<u> </u>						
R	COH	Technical Bulletin			No. RTB-006	
SUBJEC	CT: ARDF Original misfe	ed.			DATE: Mar. 15, 1993 PAGE: 1 of 2	
PREPARED BY: N. Takai/M. Furusawa FROM: Copier Technical Support Section CHECKED BY:						
Action Trou	FICATION: on Required obleshooting ofit Information	☐ Revision of service manual ☐ Information only ☐ Other		MODEL: N440 Series (A085/A087/A088)		
Symptom:						
Original misfeed occurs intermittently.						
Possible Cause:						
 The DF registration sensor is activated by paper dust on the sensor pad, affecting its color.

Technical Bulletin

No. RTB-006

SUBJECT: ARDF Original misfeed.

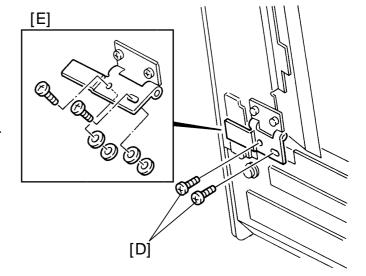
2. When the original feed roller starts rotating, the DF upper guide plate is warped slightly downward. The clearance between the DF registration sensor and the sensor pad is reduced. When this happens, the DF registration sensor (reflective type) can receive the reflective light from the sensor pad, even though its color is black.						
Actio (For ca	n Required:					
,	n the feed-in unit [A].

2. Clean the DF registration sensor surface [B] and the sensor pad [C].						
NOTE:	To remove the paper of the sensor pad, it is be use scotch tape.				[C]

(For cause 2)

- 1. Remove the two screws of the pull out hinge [D].
- 2. Insert 2 pcs each of 0.8 mm spacer (P/No. 07010040) and fix the screws. [E].
 - This can give the registration sensor enough clearance for the sensor pad.

Permanent Countermeasure:

The shape of the pull out bracket (P/No. A4651057) will be modified so that the sensor pad is positioned 1.5 mm further from the DF registration sensor.
